Monticello Nuclear Generating Plant  
Docket 50-263  
Renewed Facility Operating License  
License No. DPR-22

Monticello Extended Power Uprate: Response to NRC Mechanical and Civil Engineering Review Branch (EMCB) Requests for Additional Information (RAIs) dated March 20, 2009, and June 26, 2009 (TAC No. MD9990)

**NSPM RESPONSE TO EMCB RAIs DATED MARCH 20, 2009 and JUNE 26, 2009**

Figure 2.1: Monticello Strain Gage Layout

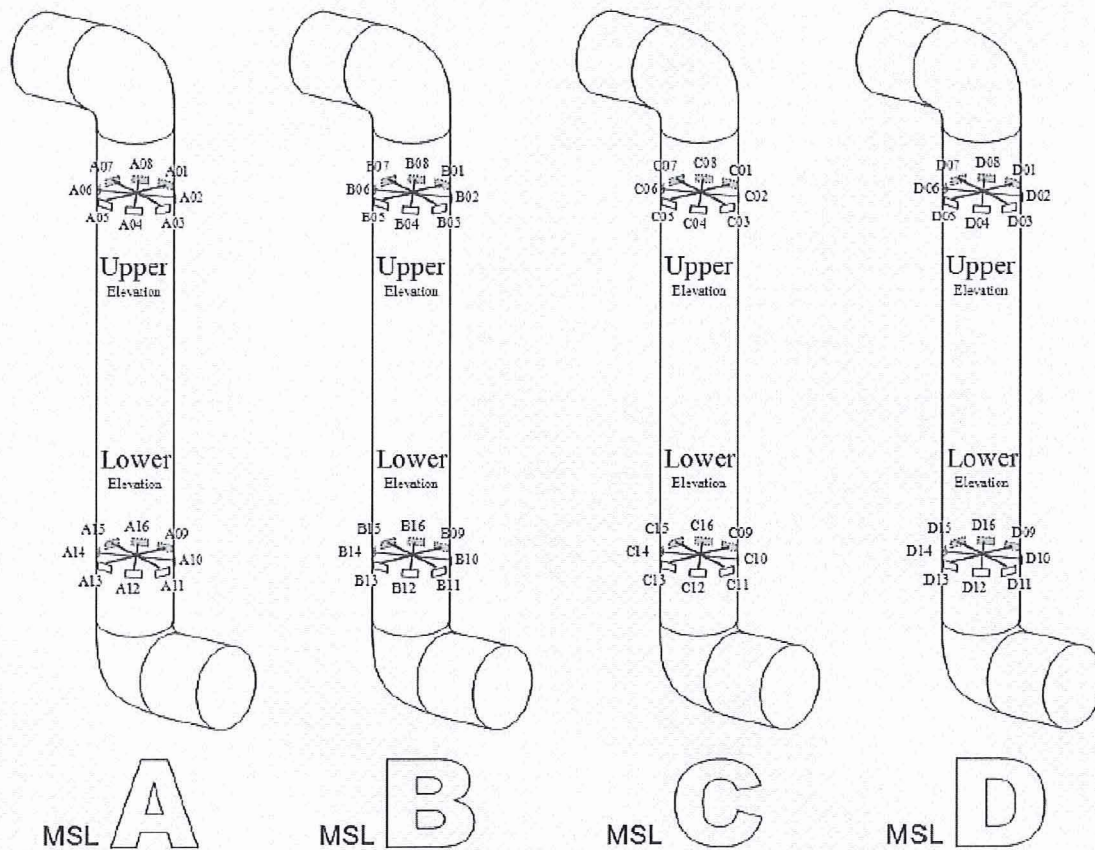
- (a) CDI Report 07-25P states that the signals due to pipe vibration have been removed from the MSL data at frequencies between 14 and 34 Hz.
- i. Provide details on how and why these signals were removed.
  - ii. At which frequencies were signals removed? How much (percentage) of the signals were removed?
  - iii. How were the peaks at these frequencies positively identified as vibrations due to pipe bending?
- (b) Did any of the MSL strain gages fail during CLTP or Low Power (LP) data acquisition? If so, provide details on the number of strain gage failures and the cause for such failures?

Strain gage installation and monitoring were undertaken by Structural Integrity and reported in SI Report No. SIS-07-001, "Monticello EPU Main Steam Dynamic Pressure Monitoring Data Acquisition Specification," wherein it is shown that eight strain gages were located around the circumference of each main steam line at two locations per line. Figure 2.1 illustrates the positions of the strain gages. Strain gage data were reported in pairs, for example A01/A05, A02/A06, etc. For the purpose of illustration, NSPM plotted the PSDs of the raw data signals for each pair, converted to pressures, for main steam lines A and B, in Figures 2.2 and 2.3. No filtering was done to these data for these plots. The original data, recorded as a function of time, were provided by SI in the file identified as 20070613105949 for CLTP conditions.

As it may be seen, strain gage pairs do not give the same pressure signal. Pipe thickness measurements and the misalignment of strain gages may be partly responsible for this effect.

Figure 4.3: Pressure contour plot produced by a unit pressure imposed at main steam line A at 99.47 Hz (top) and corresponding stress intensity (bottom).

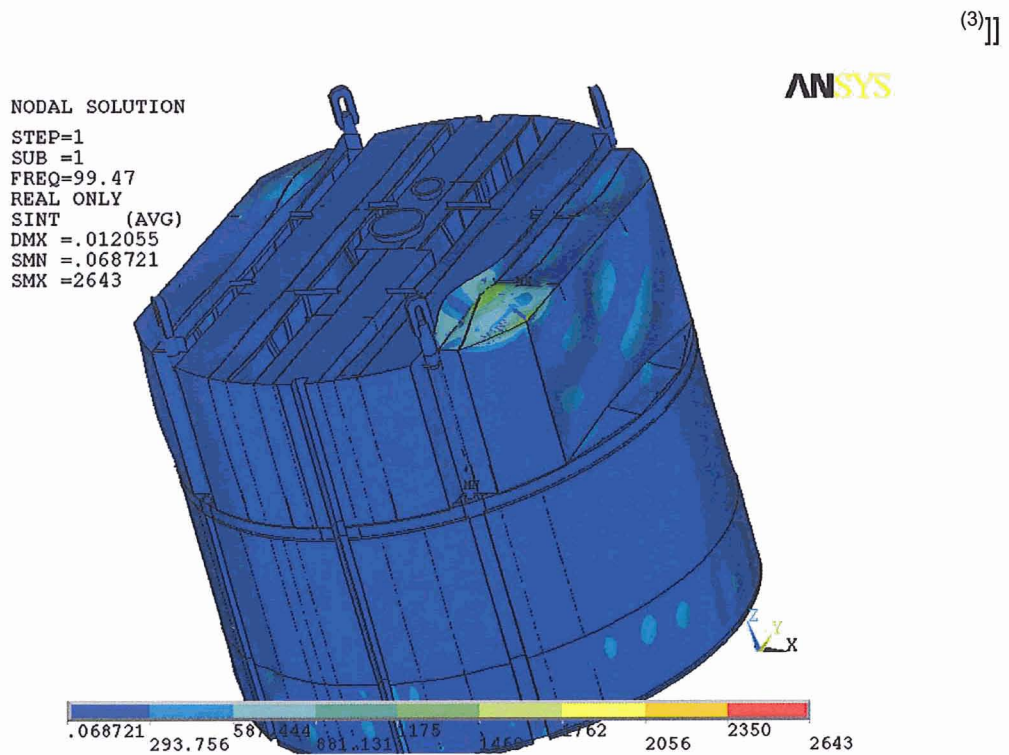
Provide contour plots and a discussion on the source of the dryer loads at frequencies near 99 Hz, where a strong peak appears in the loading PSDs in Figure 4.6 of CDI Report 07-25P.

[[
